RFI for EPR Permit Variation Application EPR/PP3237CR/V011 for Dimlington Gas Terminal

Following the permit variation application submitted on 10 April 2026, the Environment Agency sent a letter on 19 June 2026 requesting for additional information to be able to duly make the application.

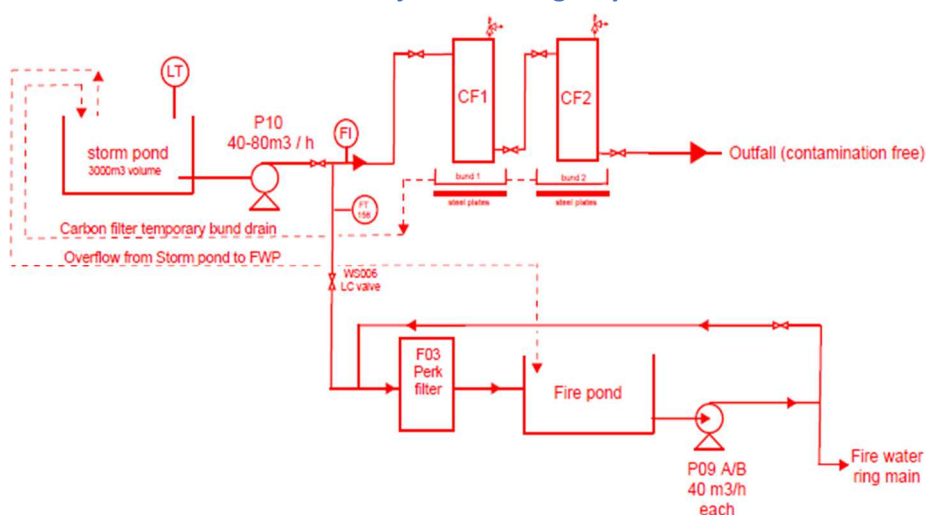
The NTS confirms that both the stormwater and firewater ponds are contaminated with PFAS but it is unclear from Figure 3 and Figure 4 how the water in the two ponds is treated before discharge.

Figure 3 indicates that the carbon filters are to be positioned between the storm water pond and the fire water pond. It's not clear whether the effluent from Carbon Filter 2 is mixed with the firewater in the pond or whether it is piped directly from the adsorber to the receiving ditch. Figure 3 also shows a line, marked in darker blue, that connects the stormwater pond and the firewater pond and it is not clear whether this is controlled in any way to prevent contaminated stormwater bypassing the carbon filters.

Figure 4 indicates that the carbon filters are located between the fire water pond and the discharge point. Figure 3 and Figure 4 therefore do not appear to depict the same configuration.

a. Please provide further explanation and a revised process flow diagram and/or site plot plan, if necessary, that clarifies how the system is configured to ensure that only treated effluent is discharged.

Figure 3: The untreated effluent from the storm pond passes through Carbon Filter 1 and then Carbon Filter 2 for the final treatment. The treated effluent is transferred into the 6 - inch pipe located within the firewater pond and discharged into the drainage ditch. There is no mixing between the treated effluent stream and the water in the firewater pond, ensuring that only treated effluent is discharged from site.

There is a valve between the storm water pond and the firewater pond that allows storm water to be transferred to the firewater pond, there is also a gravity overflow pipe fitted between the storm and firewater pond to prevent overflow.

Water from the firewater pond is taken into the firewater ring main by pumps and is distributed to all major hazard areas on site in the event of a major site emergency.

Only the water in the storm pond is treated and discharged from site.

Figure 4 in the NTS shows the current physical location of the adsorbers, the configuration remains the same despite the location of the filters.
